## ZONING APPEAL APPLICATION

Project Name Rohn Industries Trailer Parking

RE: Rohn Industries Trailer Parking - 2495 Kasota - SPR File# 19-075478

**Site Plan Review Report**

C3.01

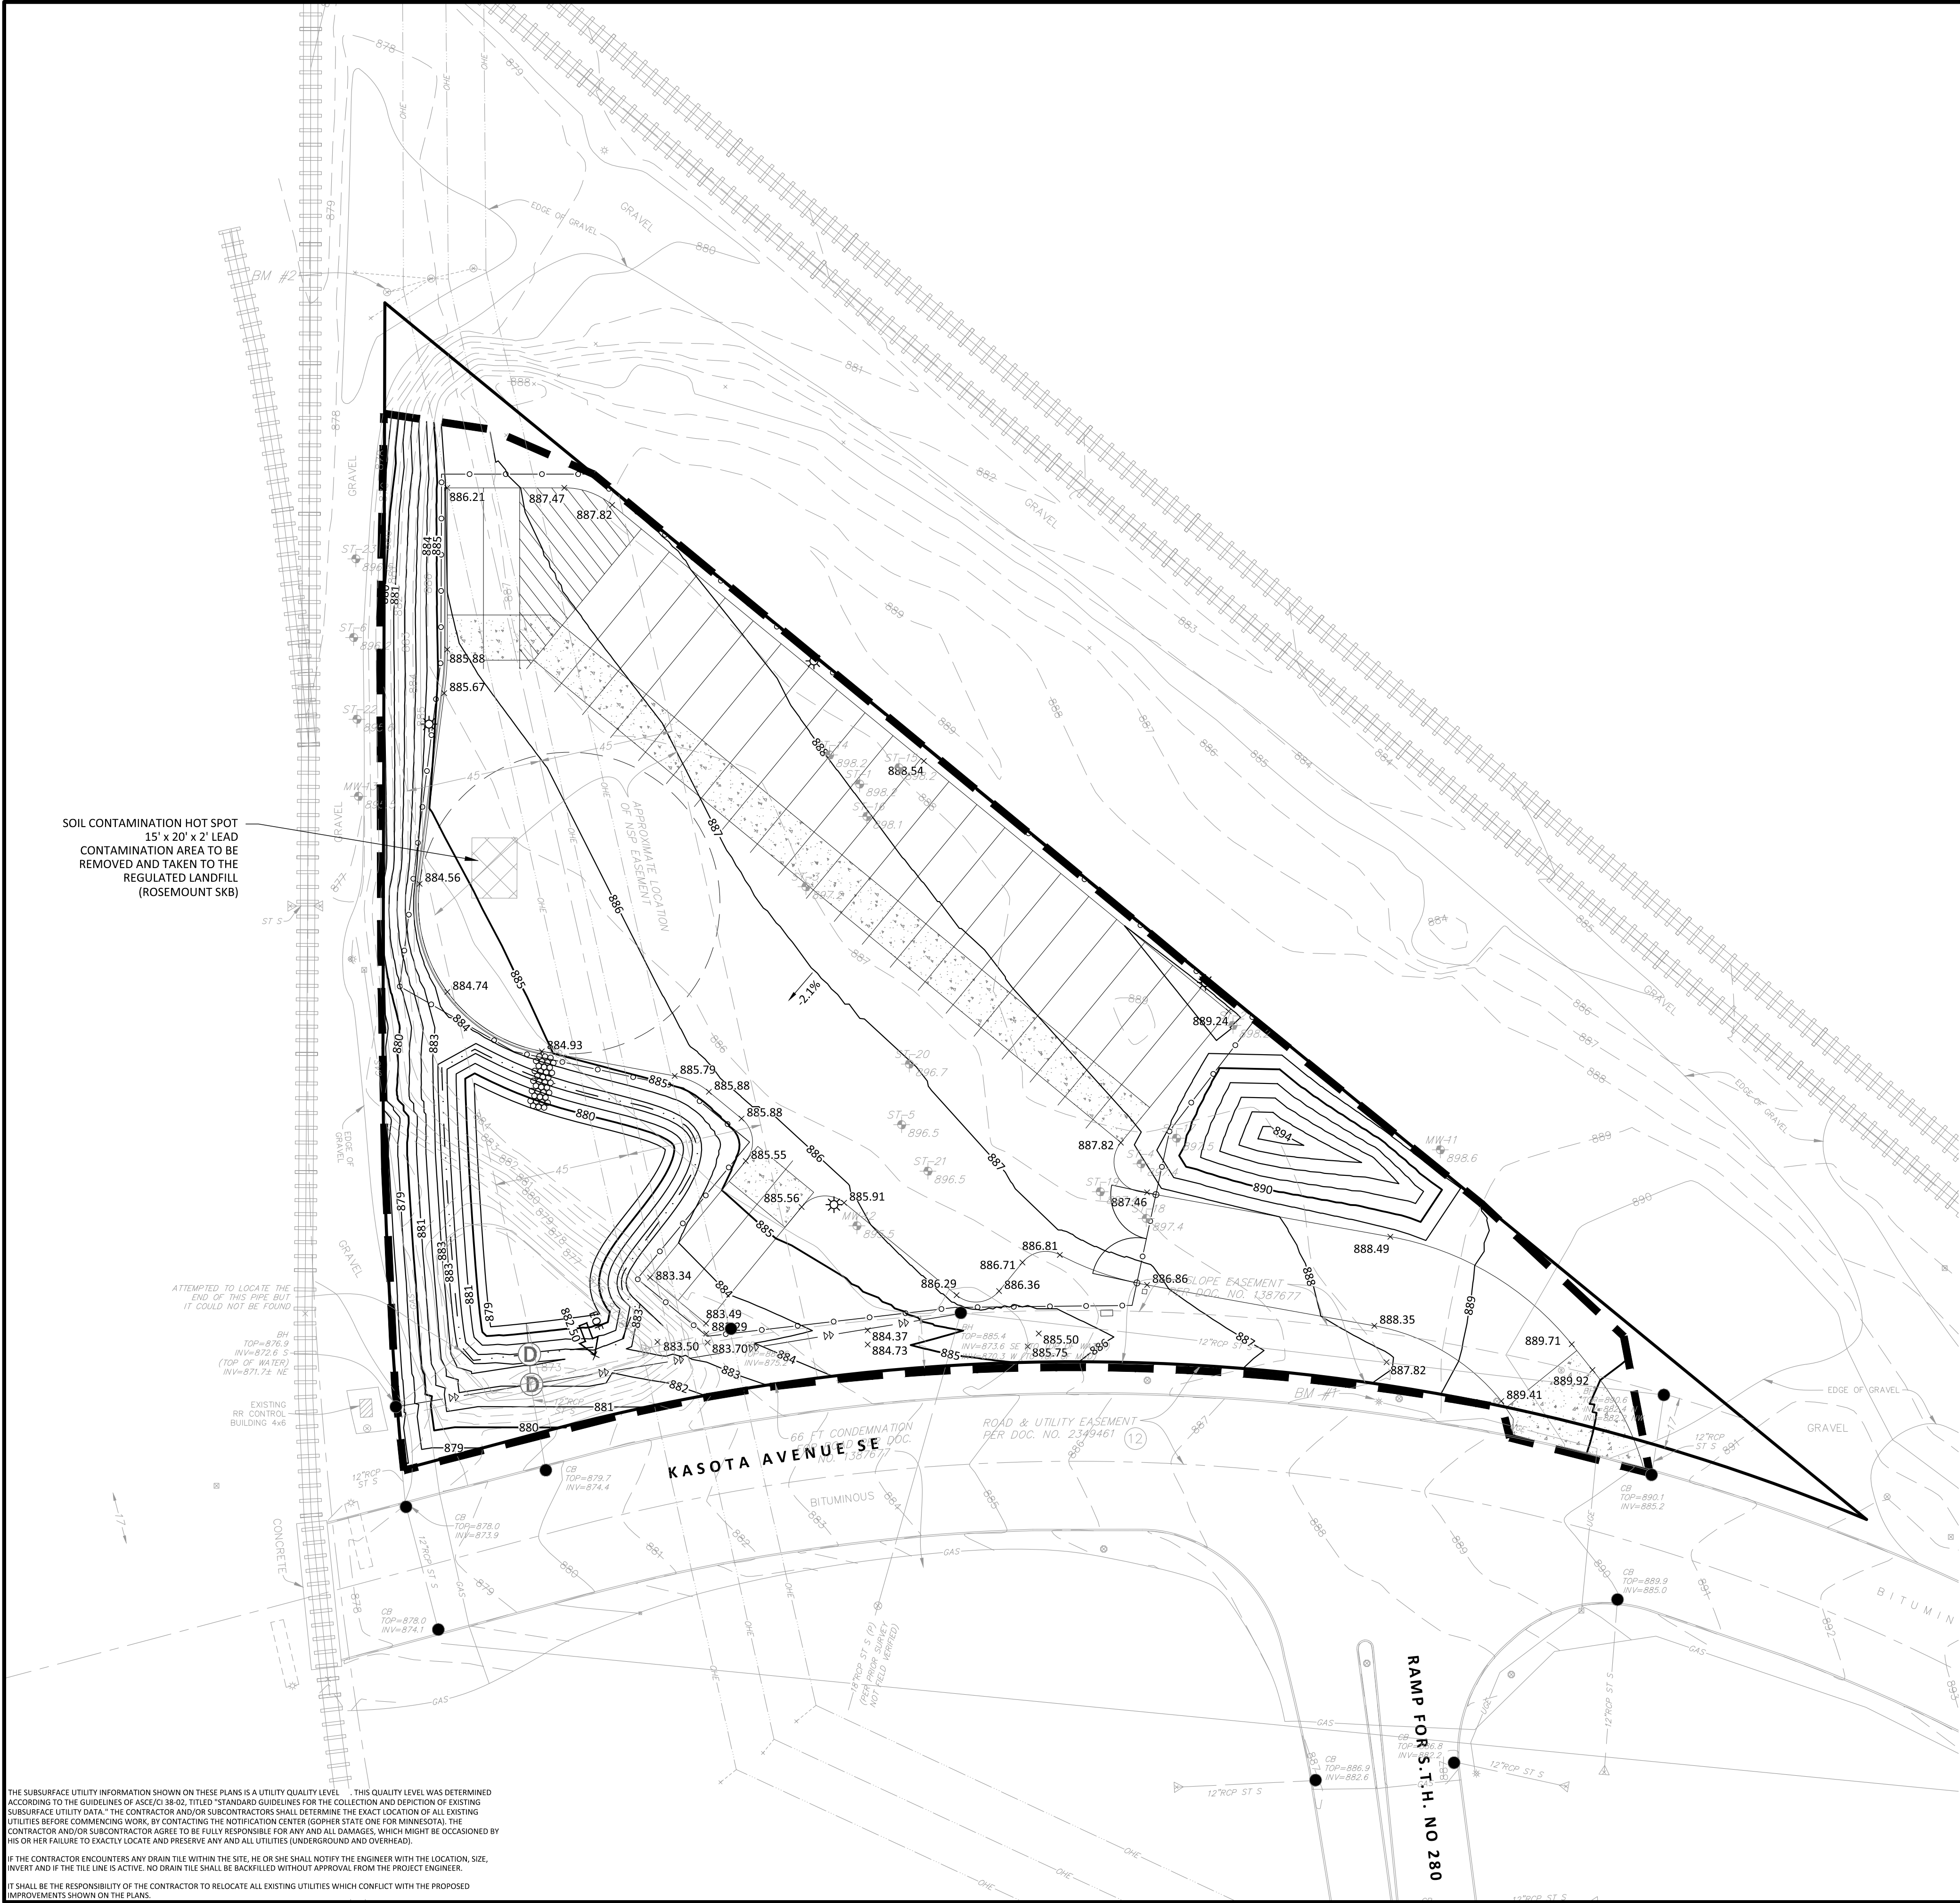
- Outdoor storage shall be fenced or walled. Outdoor storage which abuts a thoroughfare shall be behind a six-foot-high obscuring fence. *Kasota Avenue is classified as a thoroughfare. In addition to the proposed landscaping, update the site plan to include a six-foot high obscuring fence, and include a detail.*

- c) Add the street names to the plan sheets.
- d) Please use the City Standard Detail plate 1206D for driveways.
- e) Update the Site Plan with the following notes:

**Response:** Privacy slat inserts (EZ Slats by Privacy Link) will be installed in the fence adjacent to Kasota Ave to screen the trailer storage from Kasota Ave. See C3.01 for location and C9.01 for a detail.

**Response:** There will be no proposed business sign at this site. An address sign will be installed near the gate, see C3.01.

**Response:** Theses notes have been added to sheet C3.01.

**Response:** Address sign and key box added near the front gate, see sheet C3.01.

Sheet No. Revision  
**C9.02**

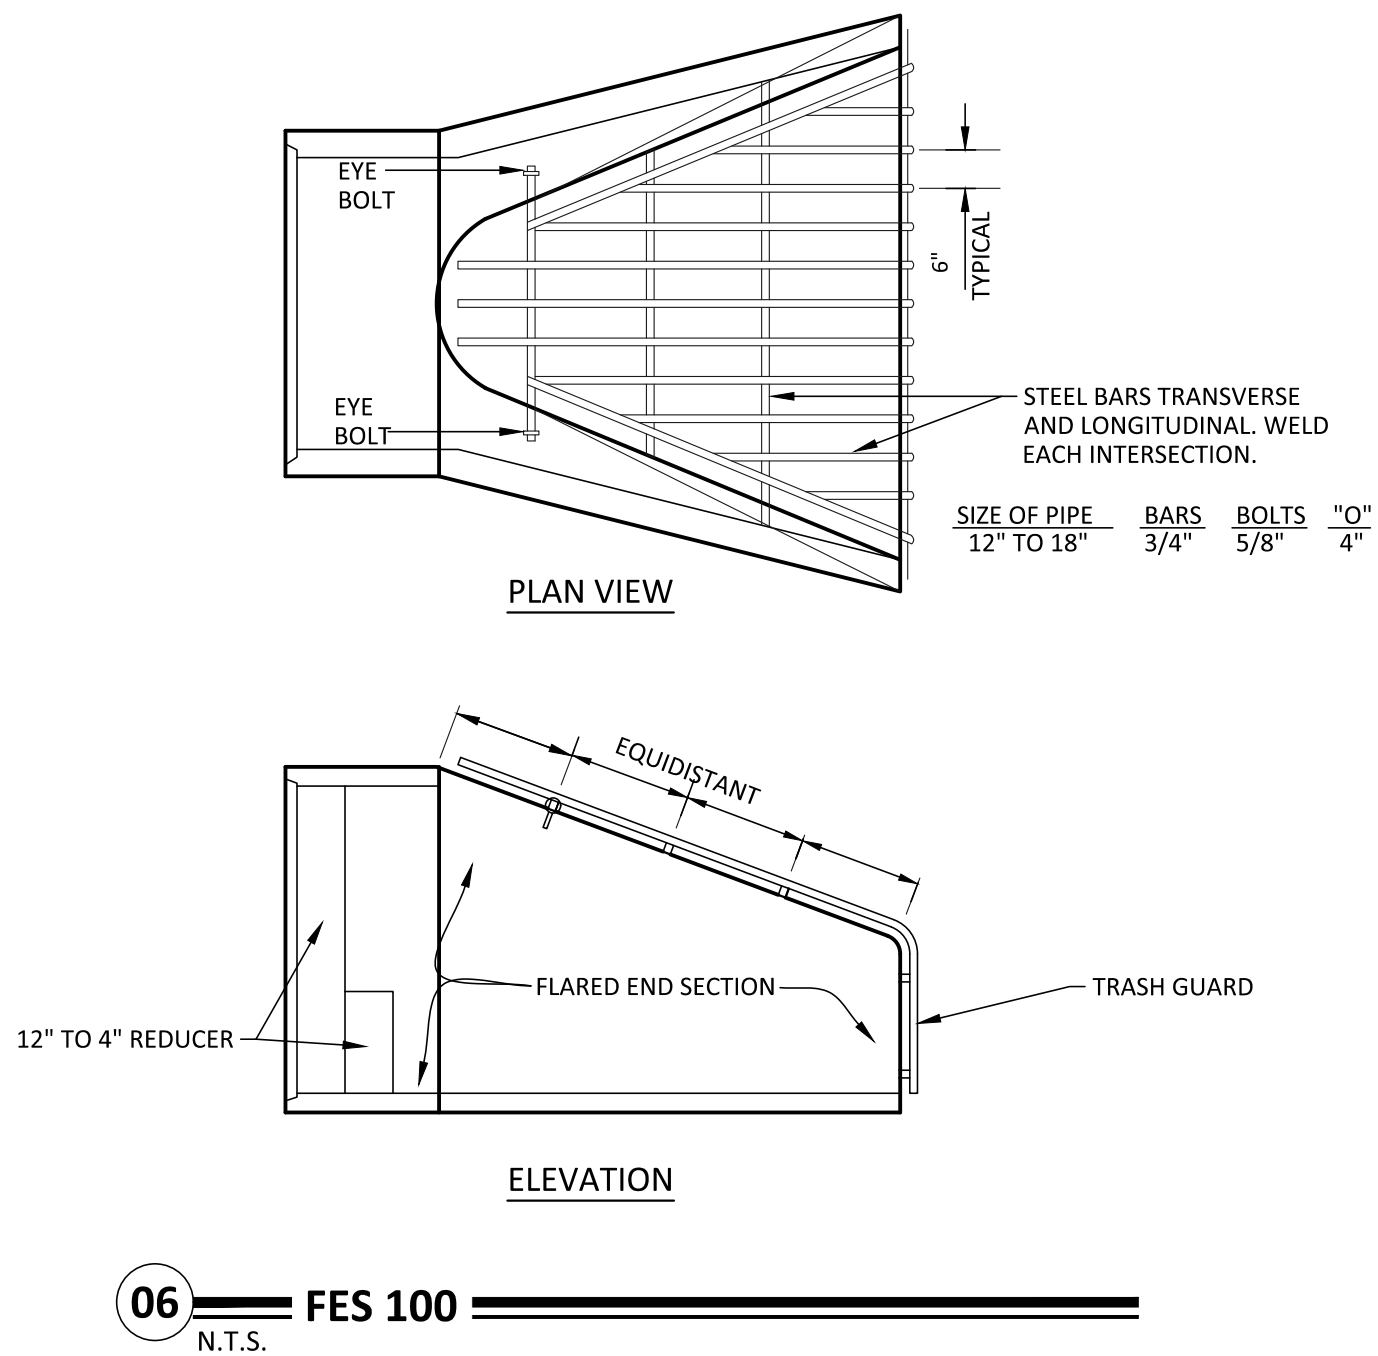
- Please provide a detail of the proposed 4-inch orifice. As well, will there be a skimmer structure to prevent clogging?
- **Response:** A detail of the pond outlet (FES 100) has been added included the 4" to 12" pipe transition and trash guard. See detail 06 on C9.02.

Sheet Title  
**TRUCK TURN EXHIBIT WB-67**

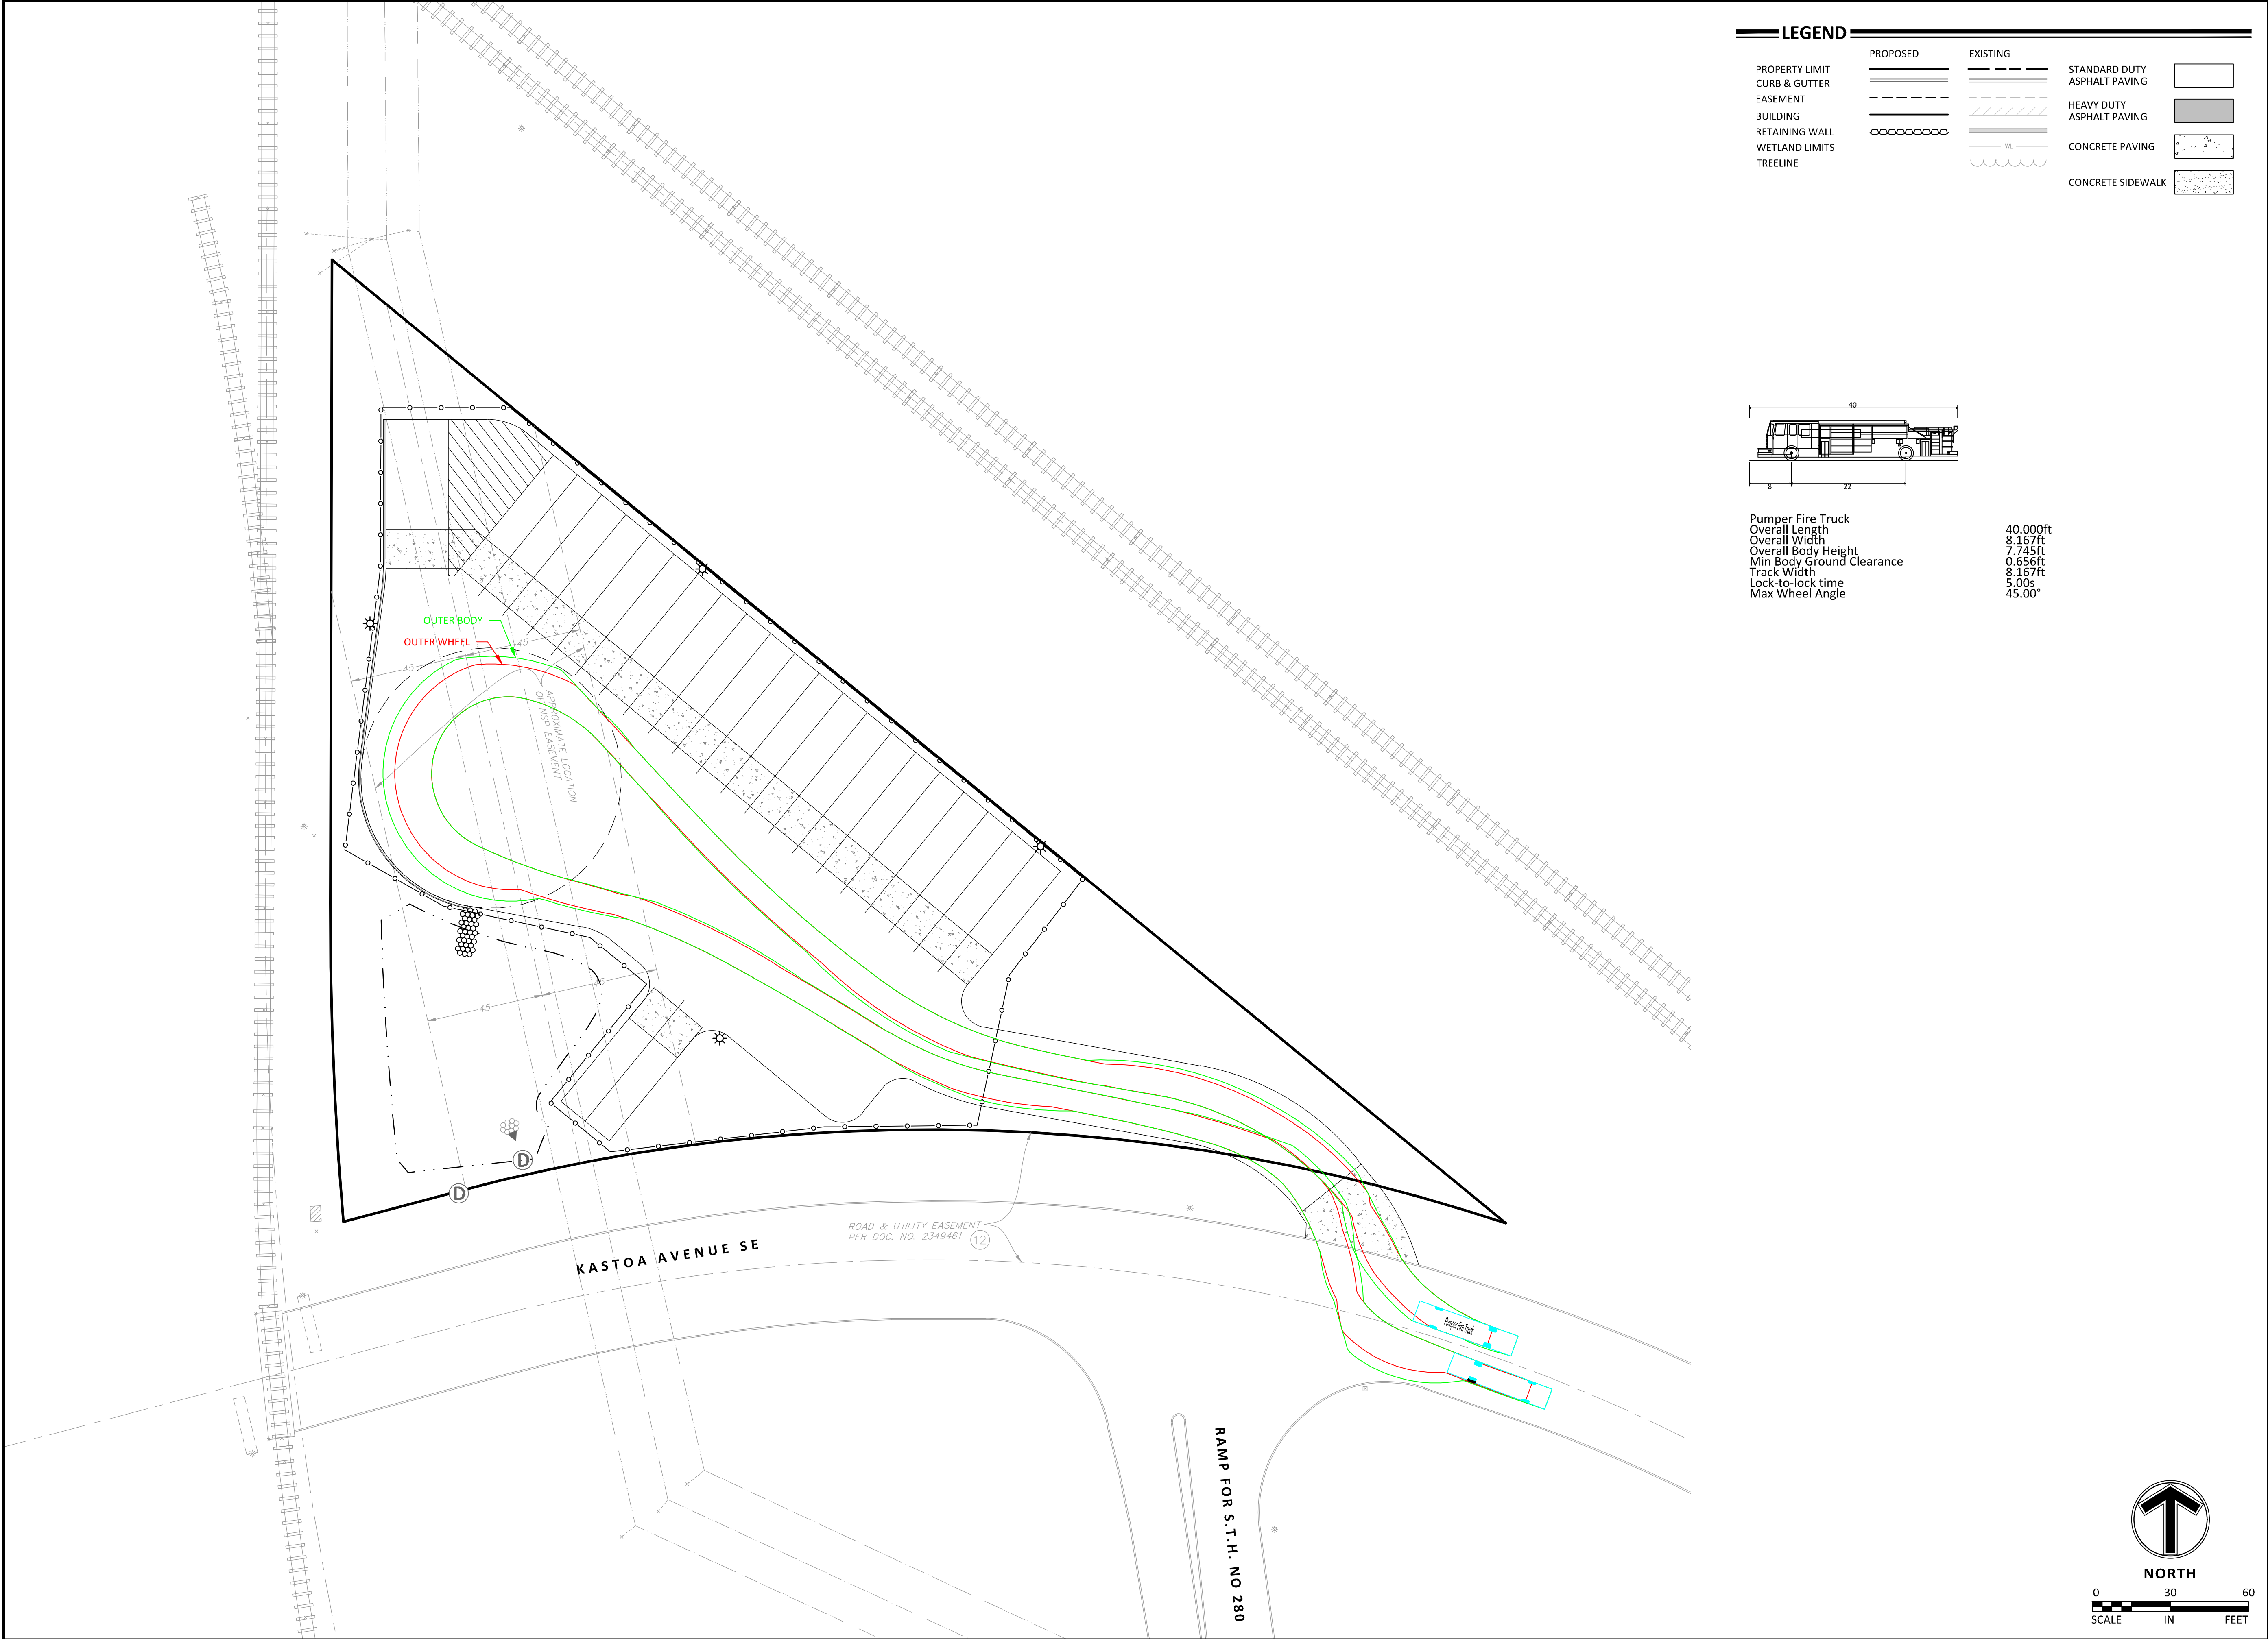
8. Under Public Works Transportation Planning item 9, we believe it would be a minimum of care to do a thorough traffic study, including turning movements in and out of the site in every direction as well as within the site for the appropriate design vehicle (WB 67 semi-truck / trailer).

There will be a very well-defined traffic pattern between the recycling facility at 862 Hersey Street and the proposed 2495 Kasota Ave trailer staging site, and that pattern served as the basis for the proposed site design. Trucks entering the site will be required to come from the 862 Hersey Street location and will approach from the East on Kasota Ave at which point they enter via the curb cut placed very near the East edge of the site. A very generous and wide angle of approach will facilitate a very easy truck movement. Likewise, trucks exiting the site will have a similar movement as they exit back to the East on Kasota Ave. The entrance driveway has been designed with more than sufficient length to allow for entering and exiting trucks to be fully clear of Kasota Avenue when stopped at the entrance gates. The plan has been engineered to support 53' trailers, specifically wb-67 truck movements as illustrated in the attached *Truck Turning Exhibit*.

MnDot right of way is not utilized or impacted by these traffic patterns.
